Changes:

DESIGNED BY: Alex Anastasakis		<div>Cover</div> <div>Course: Industrial Design for Game Hardware</div>		I	—
DATE: 2024-11-26				H	—
CHECKED BY: Alvaro Uribe Quevedo				G	—
DATE: 2024-11-29				F	—
SIZE				E	—
A3				D	—
SCALE				WEIGHT (kg)	DRAWING NUMBER
1 : 4		3	1 / 1	C	—
This drawing is our property; it can't be reproduced or communicated without our written agreement.				B	—
				A	—

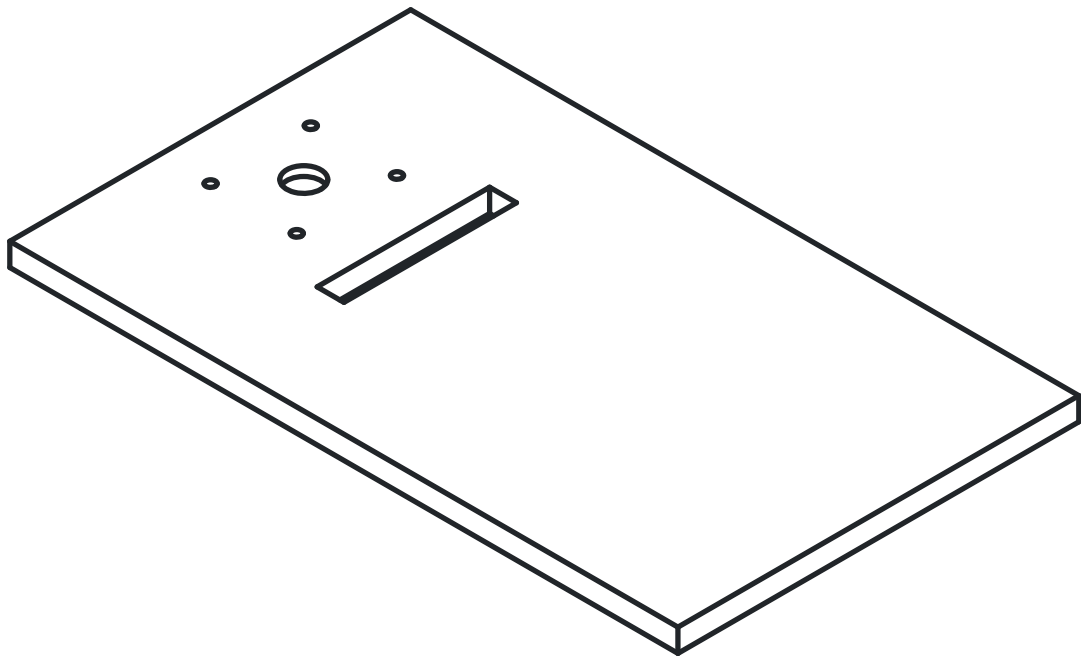
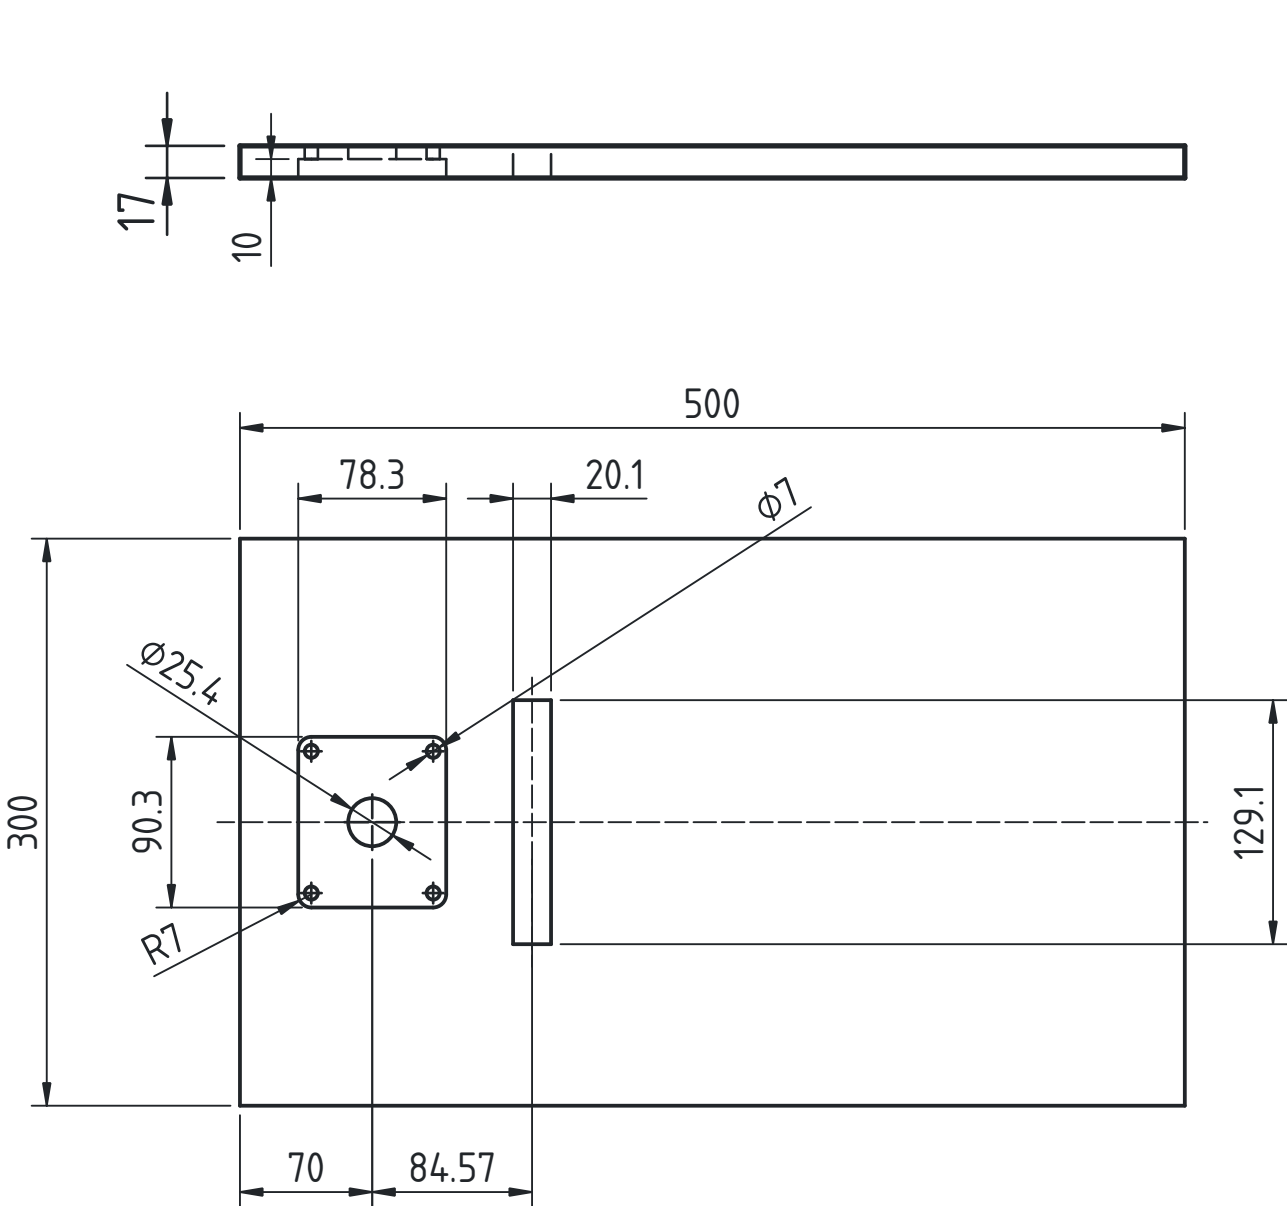
- The joystick's mounting was moved to the bottom of the cover, because this is how they're meant to be mounted
- The box was made larger due to user feedback stating that the previous, smaller design made them afraid of missing the strike face and/or hitting themselves.
